LIVING WITH HISTORY

## Certificate of Appropriateness

**Property** 2543 N. 47<sup>th</sup> St. 47<sup>th</sup> Street Bungalow HD  
**Description of work** Install three circular vents on the north side of the home to accommodate the installation of new hot water heater and boilers. The vents will be concealed by chimney outcropping and existing hedges and fencing.  
**Date issued** 9/24/2019 PTS ID 114862 COA HVAC vents

Photo of northeast corner of the home where vents are to be installed  
Annotated photograph details the location of the vents in relation to existing shrubs and the chimney

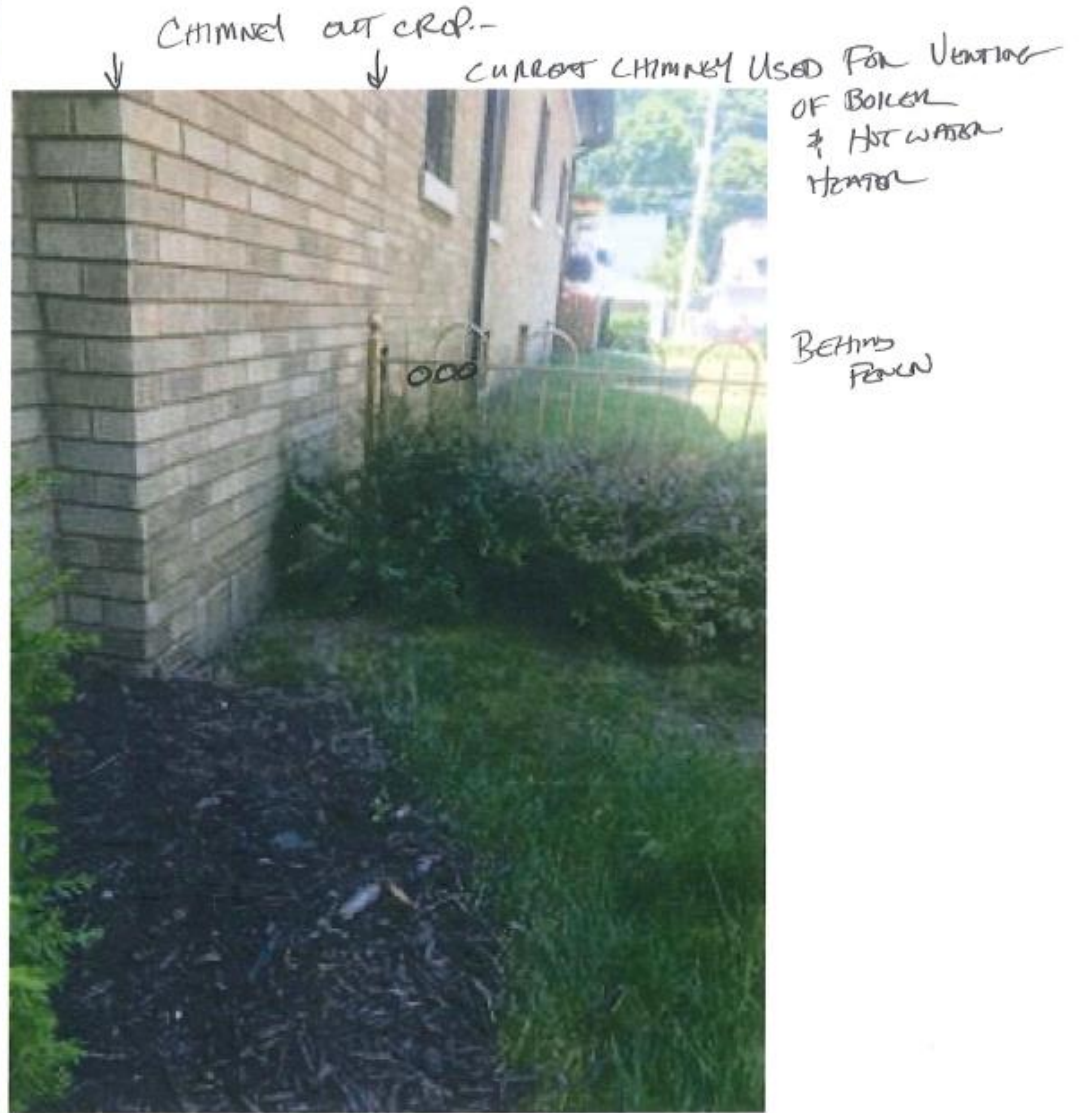
The north side of the home where the vents are to be installed – **vents shall be painted to match the color of the surrounding brick**
